Origination Form
Proposed Revisions to a Standard Plans Index

Originator:	Turley, Joshua	Index Number:	649-031
Date:	4/18/2025	Sheet Number(s):	Sheet 1
E-mail:	Joshua.Turley@dot.state.fl.us	Index Title:	MAST ARM ASSEMBLIES

ELEVATION AND NOTES

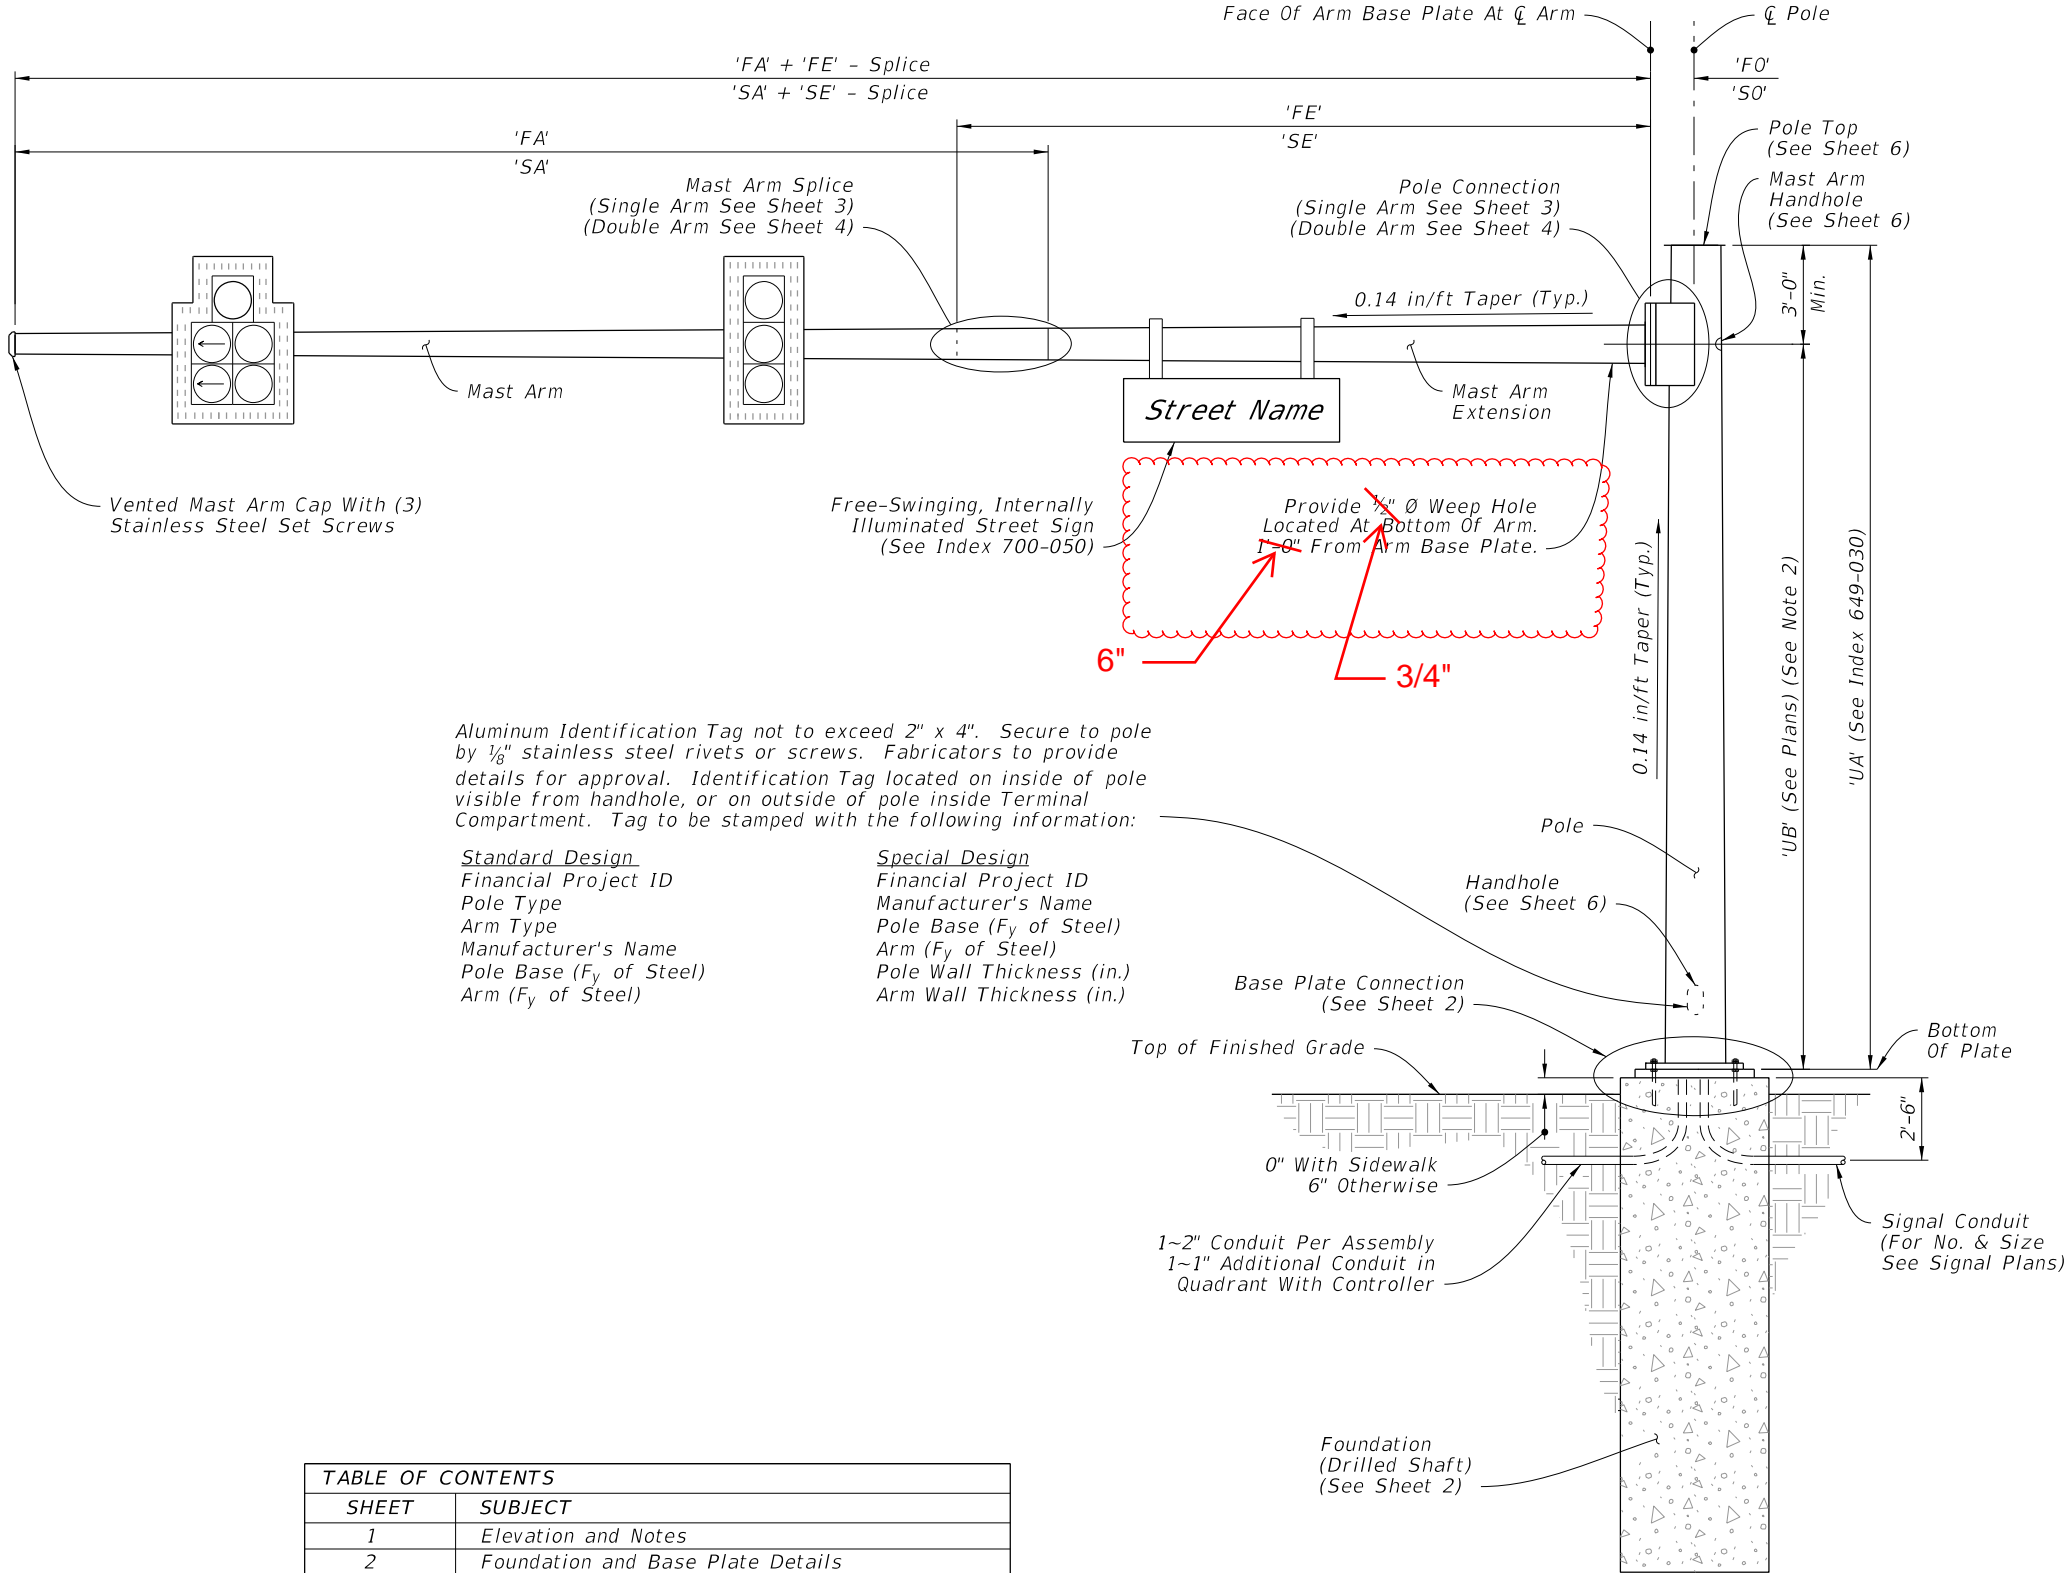
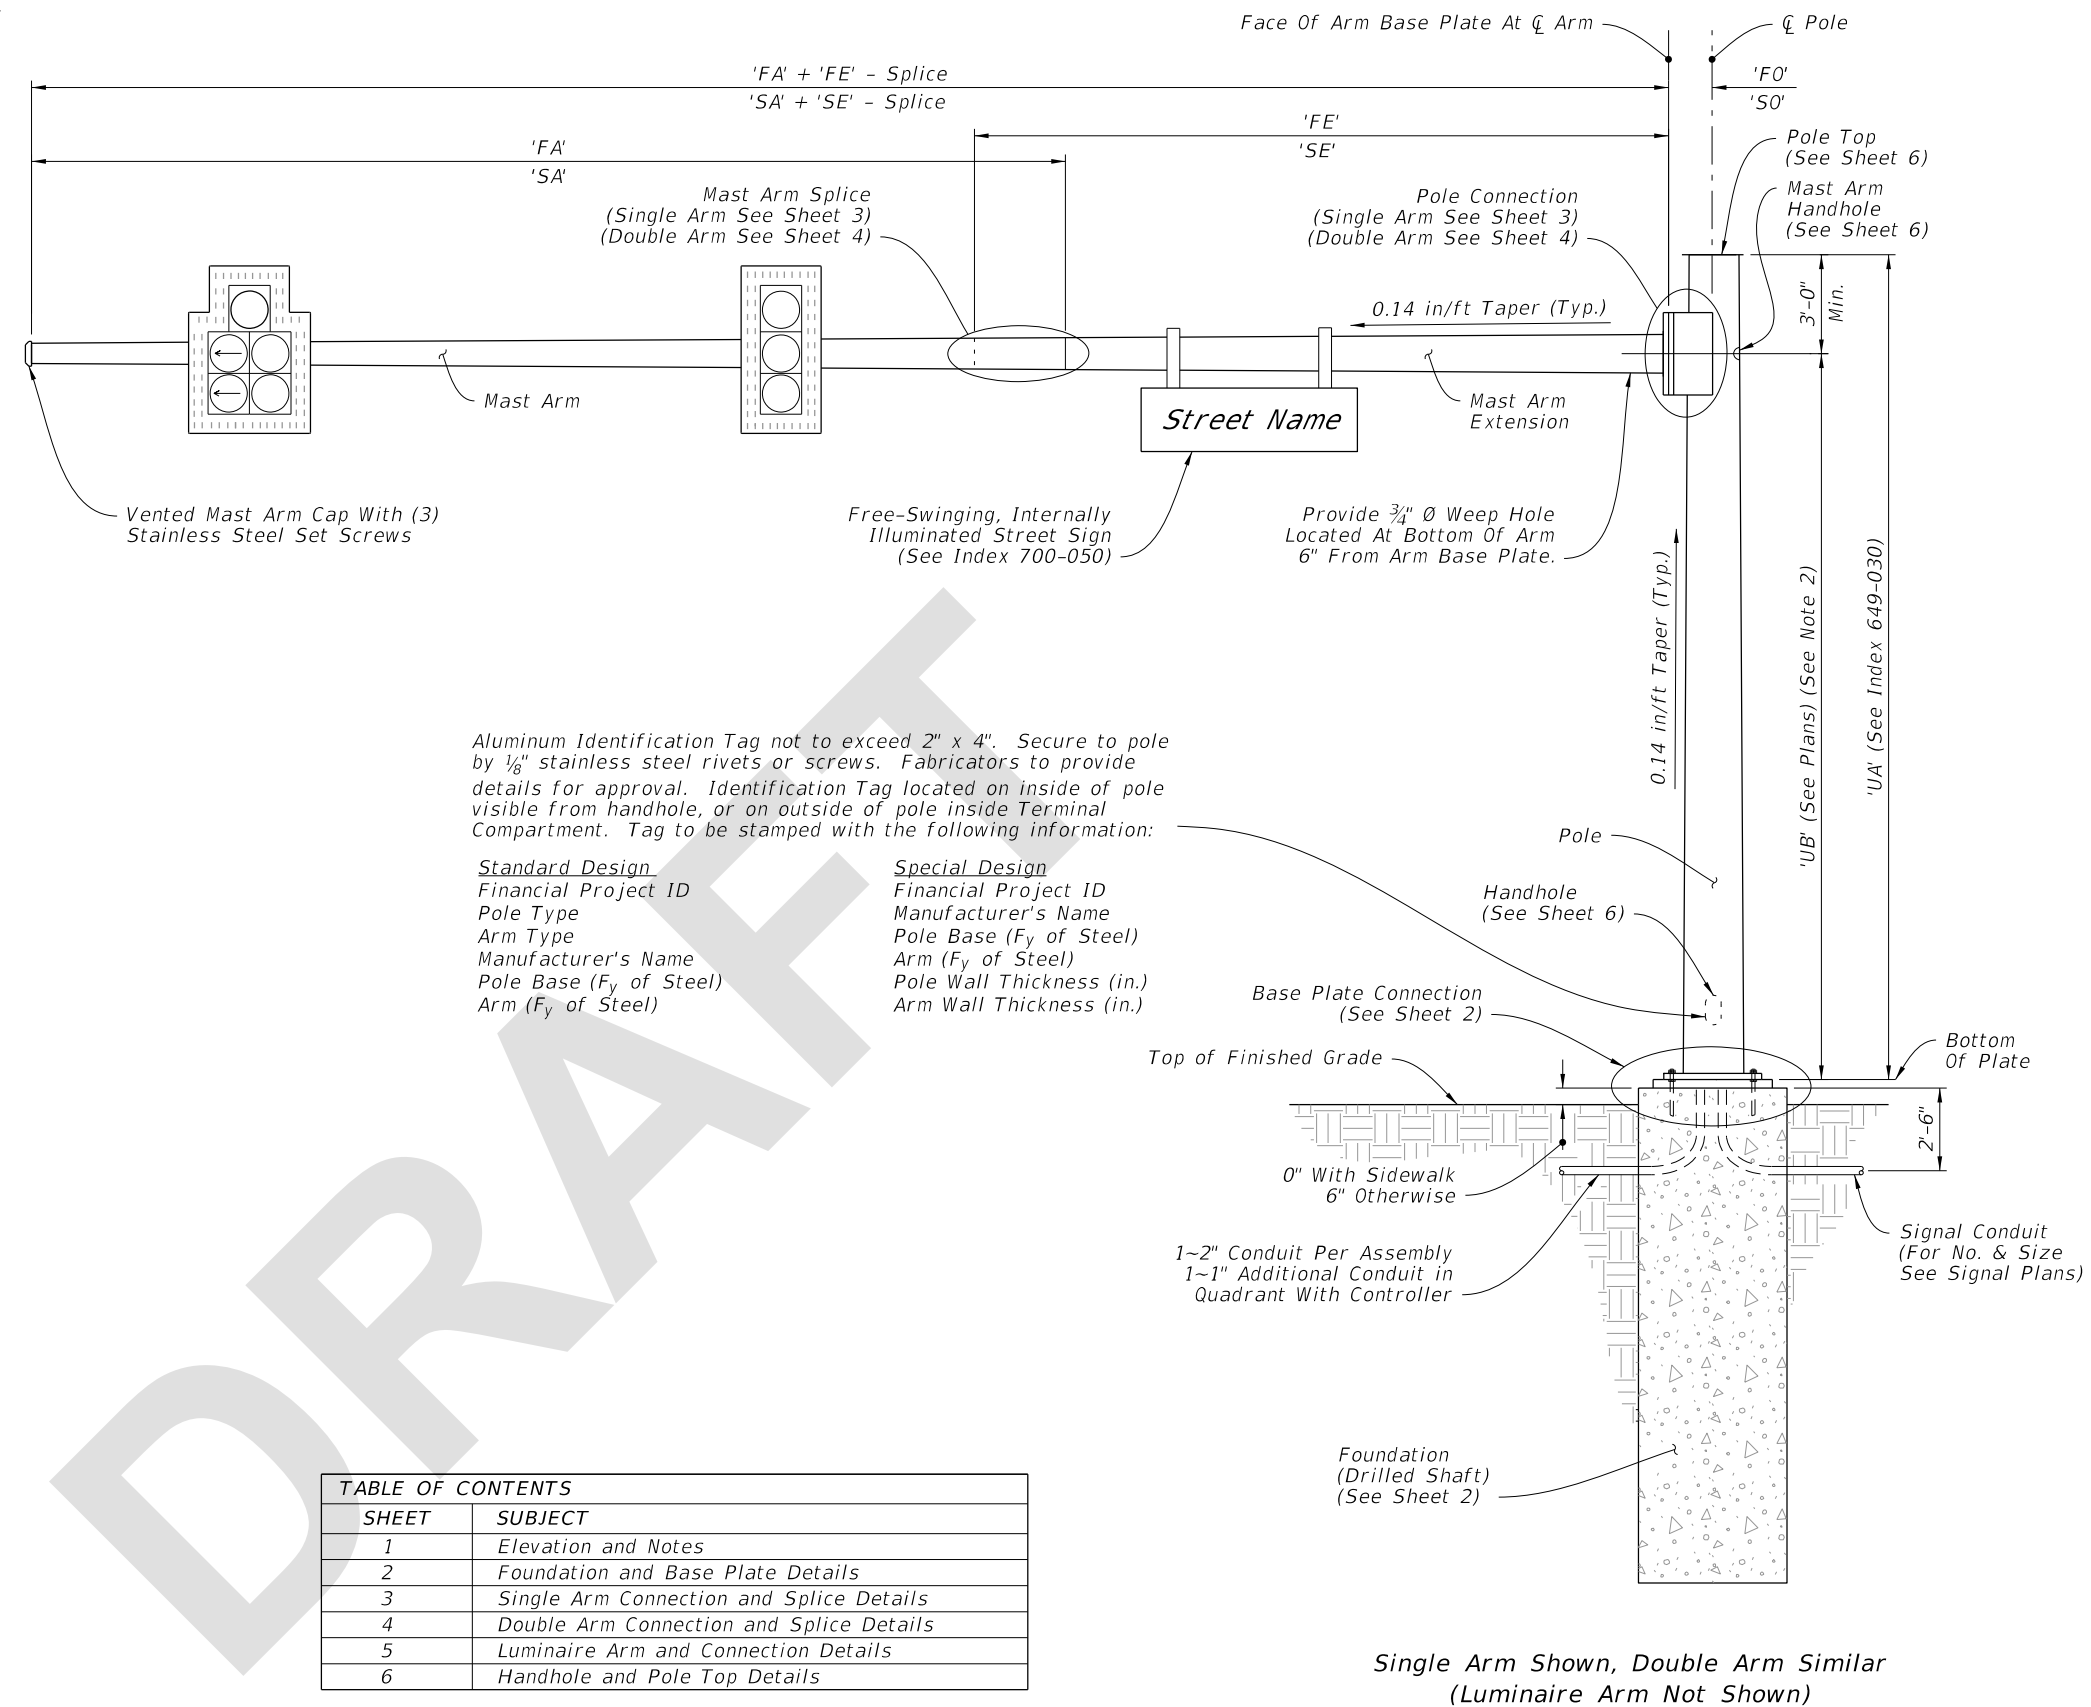
Sheet 1: Moved the weep hole closer to the arm from 1' to 6" from the base; Changed Weep Hole size to 3/4".

Sheet 1: There was some concern that water may pond at the arm to pole connection potentially causing corrosion due to the angle at which the arm attaches to the pole. The poles are galvanized on the inside which helps resist corrosion but shifting the weep hole closer can aid as well by reduce the volume of water that could potentially pond.
